ADDENDUM NO. 2

RE: Item #2, June 11, 2014 Letting - P 0044(149)40, P 0044(00)40, PCN 6925, 04QJ, Pennington County - Grading, Storm Sewer, Curb & Gutter, PCC Paving, Lighting and Signals

PLANS: Please destroy sheets A2, B2, C3, C4, F2, F3, F5, F7, and F15 and replace with the enclosed sheets, dated 6/5/14 and 6/6/14.

Scale 1 Inch = 40 Feet
Sheet 4 of 12 Sheets

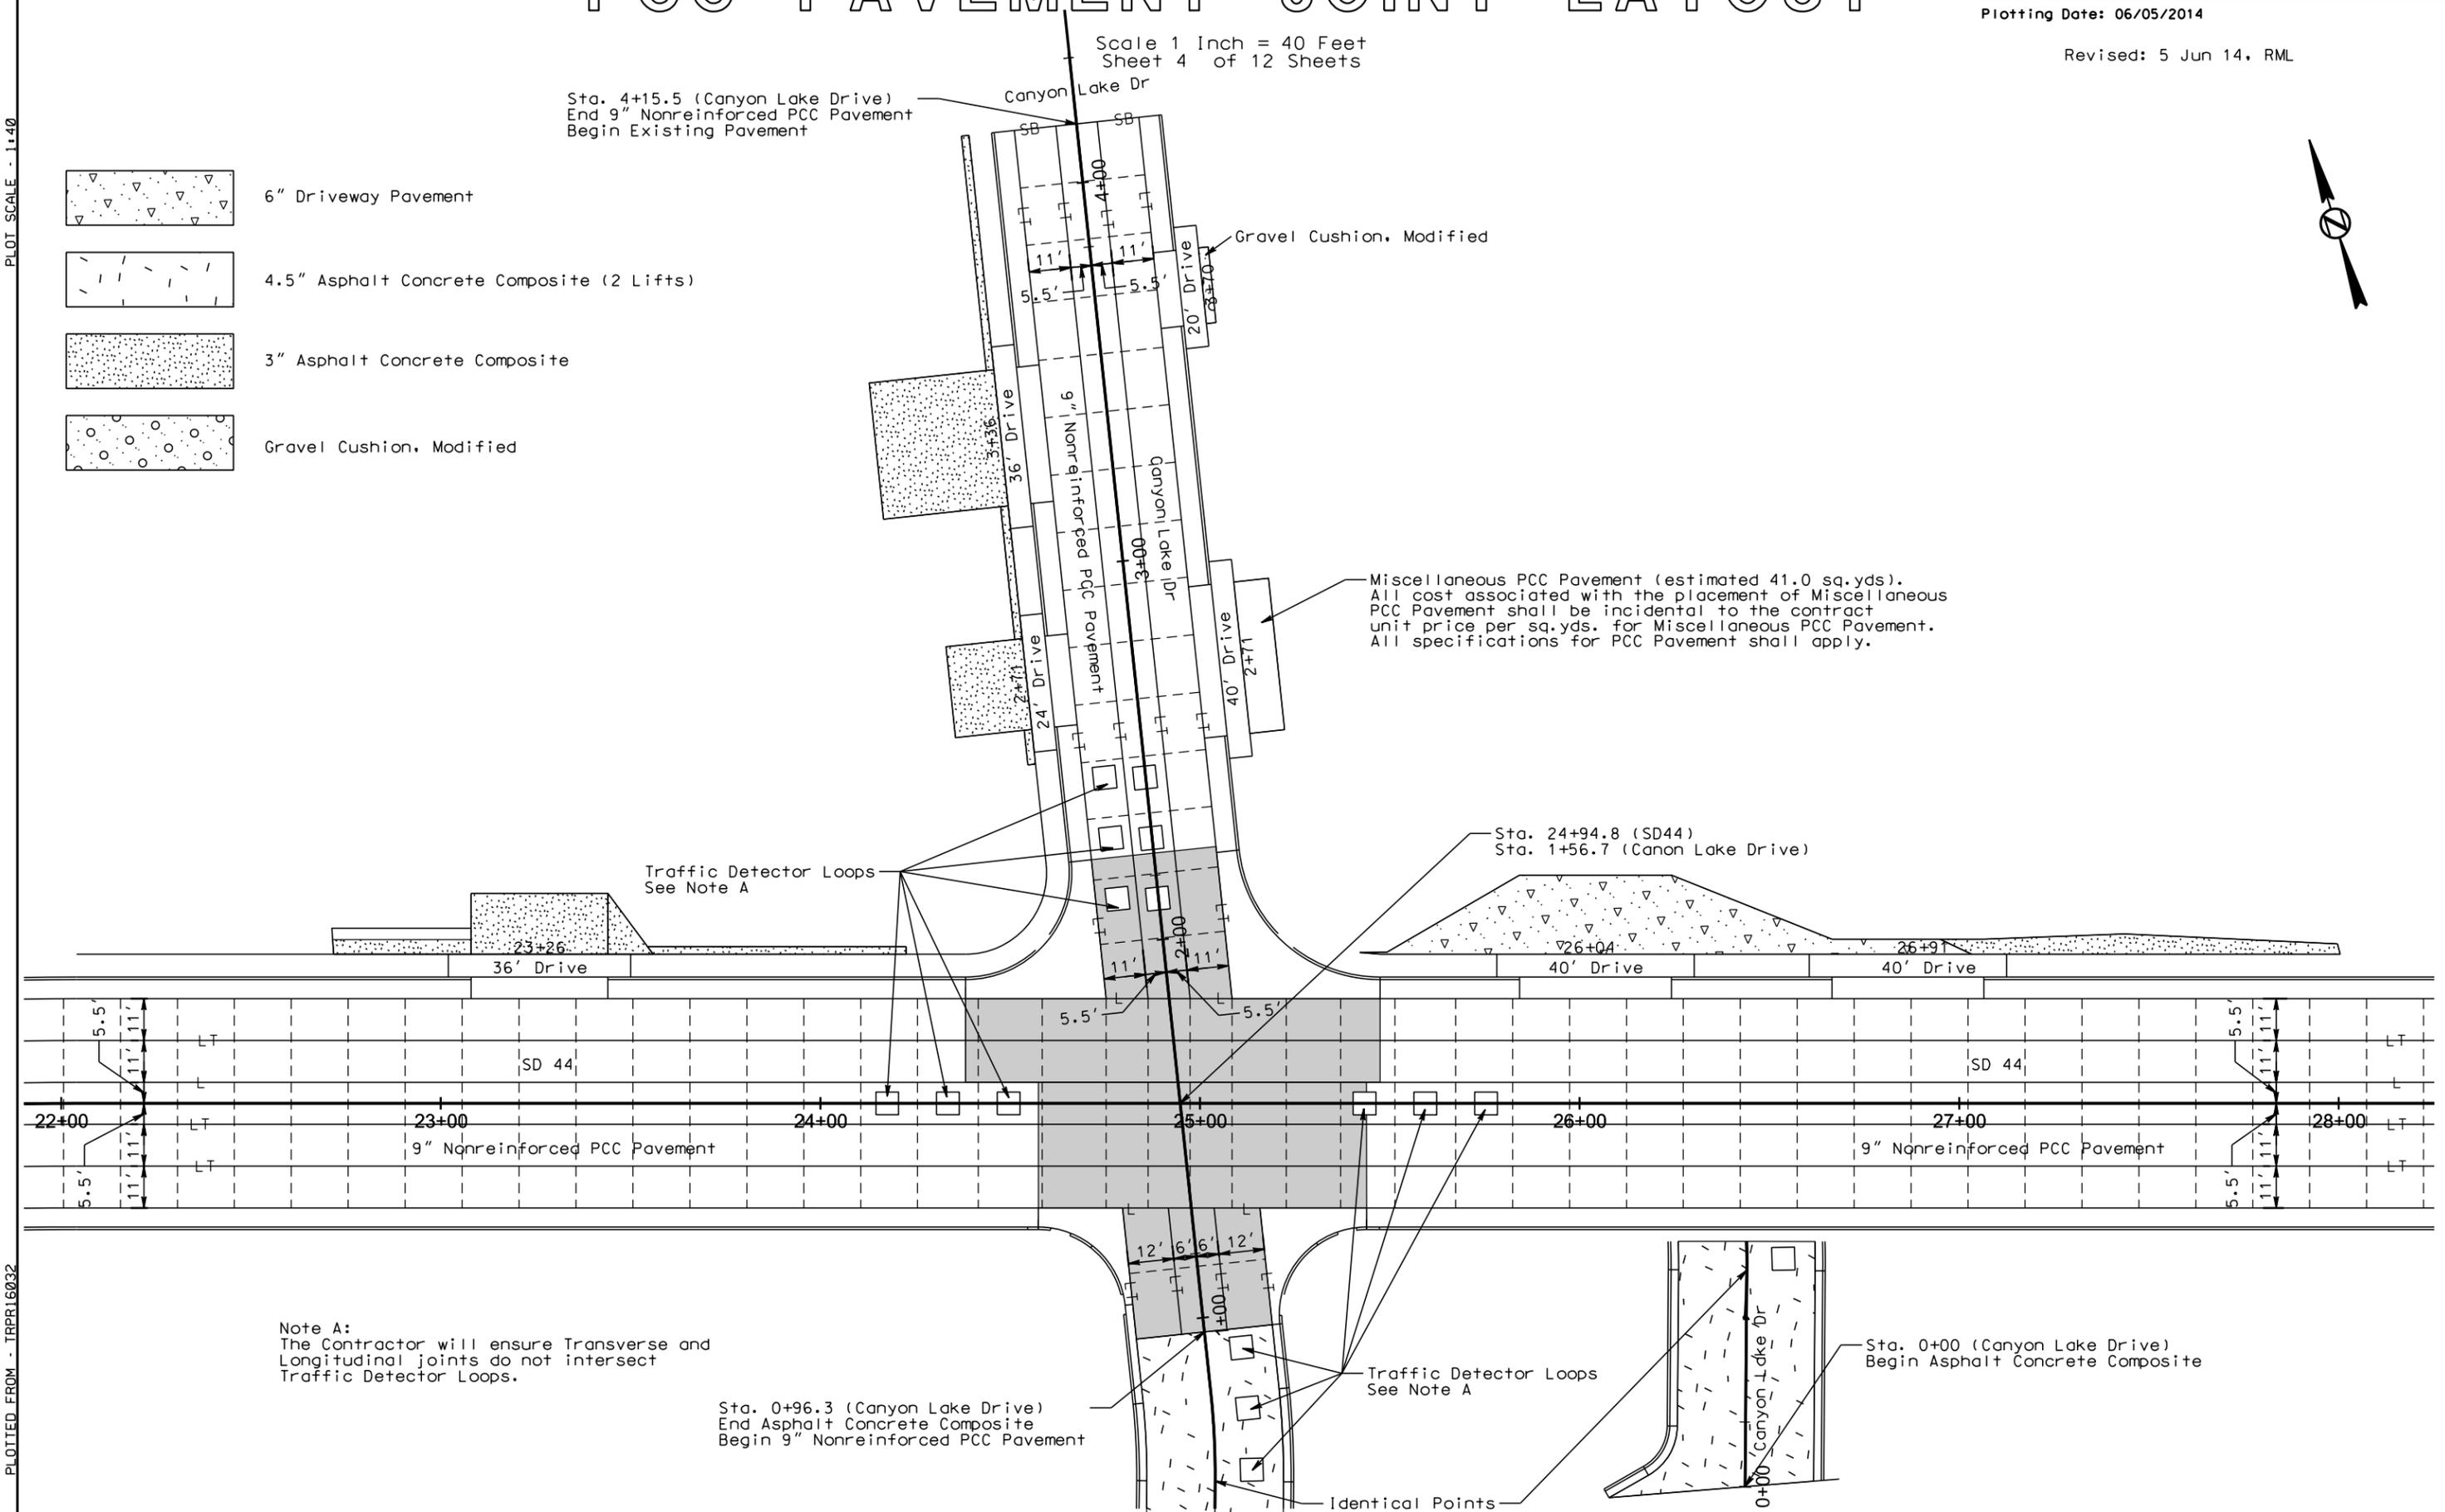
Sheet F15: PCC PAVEMENT JOINT LAYOUT was revised.
